Access Compliance Report

Public Rights-of-Way

(Curb Ramps)

Intersection ID: 50320	Main Street: BRYN_ATHYN_CT	Cross Street: CINDY_LN	Location: SW
ADA ID: AA2B6E7AC953	Ramp Type: Directional1	Initial Pass/Fail: Pass	Overall Compliance: No
Severity Score: 2.5			
Codes/Mitigation Info/Possible Solution		Field Measurements/Component Compliance

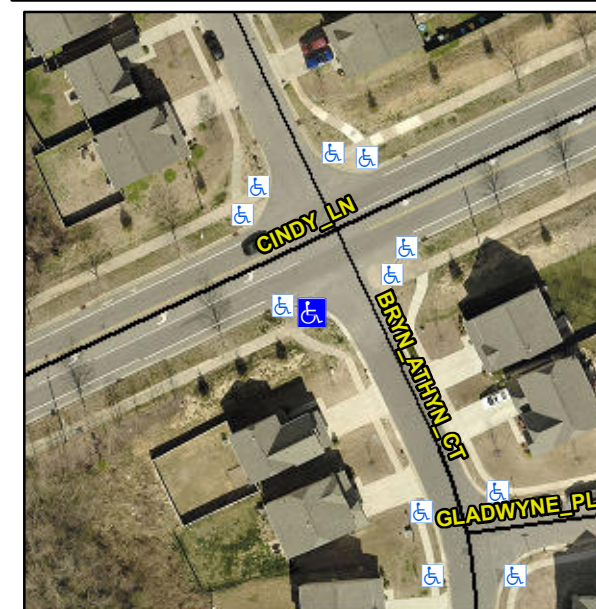
R304.2.2-Perp, R304.3.2-Para, R305.1.4, R305.2

Compliance	Description	Data	Compliance	Description	Data
N/A	Ramp Length (in)	134.0	Yes	Grade Break?	Yes
Yes	Ramp Width (in)	66.5	Yes	Grade Break Slope (%)	2.8
Yes	Ramp Slope (%)	5.1	Yes	Grade Break XSlope (%)	1.7
Yes	Ramp XSlope (%)	1.1			
Yes	Flare Type LT	N/A	Yes	Flare Type RT	N/A
N/A	Flare Slope LT (%)	N/A	N/A	Flare Slope RT (%)	N/A
N/A	Flare Traversable LT?	No	N/A	Flare Traversable RT?	No
Yes	Landing Length (in)	72.0	Yes	DWS Provided?	Yes
Yes	Landing Width (in)	70.0	Yes	DWS Contrast?	Yes
No	Landing Slope (%)	2.2	Yes	DWS Length (in)	24.0
Yes	Landing X Slope (%)	1.3	No	DWS Full Width?	No
N/A	Landing Curb? (Y/N)	N/A	Yes	DWS Offset LT (in)	42.5
N/A	Shared Landing?	Yes	No	DWS Offset RT (in)	8.0
Yes	Gutter Ponding?	No	Yes	Gutter Slope (%)	1.8
Yes	Gutter Lip Ht (in)	0.0	Yes	Gutter X Slope (%)	1.0
N/A	Painted X Walk1?	No		Road Slope (%)	3.5
	X Walk 1 Direction	To E		Road X Slope (%)	1.2
	X Walk 1 Width (in)	N/A		Clear Space?	Yes

X Walk 1 Slope (%)	3.5	N/A	Clear Space to XWalk (in)	N/A
	X Walk 1 X Slope (%)	1.2	Yes	Storm Grate/Utility Hazard?	No
N/A	Ramp inside XWalk1?	N/A		Storm Grate/Utility Type	
Yes	Any Obstructions?	No			N/A
	Obstruction Type		Yes	Surface Condition? (G/P)	Good
			N/A	Curb Slope (%)	5.7

Remove & Replace Entire Ramp.
